Contract #: 04-0120F4Cty: SF/ALA Rte: 80 PM: 13.2/13.9File #: 69.25B**QUALITY ASSURANCE -- NON-CONFORMANCE REPORT****Location:** Changxing Island, Shanghai, P.R. China**Report No:** NCR-000280**Prime Contractor:** American Bridge/Fluor Enterprises, a JV**Date:** 26-May-2009**Submitting Contractor:** Zhenhua Port Machinery Company, Ltd (ZPMC), Changxing Island**NCR #:** ZPMC-0254**Type of problem:**

Reference Description: Missed UT Indication by QC Technician, SB006-028**Description of Non-Conformance:**

Subject: NCR No. ZPMC-0254

Subject: NCR No. ZPMC-0254

WELD NUMBER: SB006-028-007

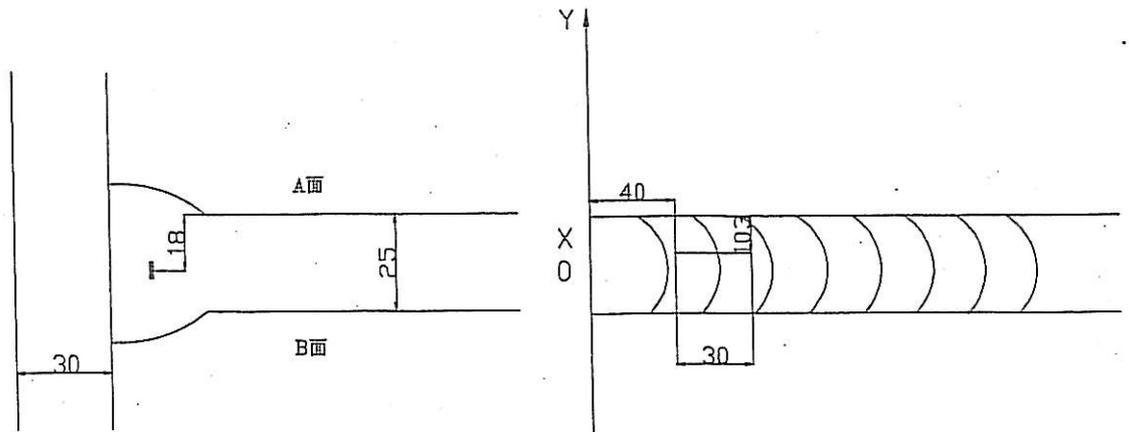
Description of welding discontinuity:

Rejected indication found by ultrasonic inspection is less than the maximum allowance aggregate length.

(UT探伤发现的缺陷总长度小于最大允许长度。)SB006-028-007

Caused:

1. Did not clear the weld pass completely in time.

Disposition :

1. Gouge or grind from nearer side from metal edge ($D \leq 0.65T$, "D" is depth of defects, "T" is thickness of metal) to remove all defects;
2. Follow repair WPS for joint preparation, preheat, and weld deposit;
3. Verify with VT no defects remain in the weld joint prior to welding;
4. Grind the repaired area flush with base metal or the adjacent weld;
5. Check the welds according to the working drawings.
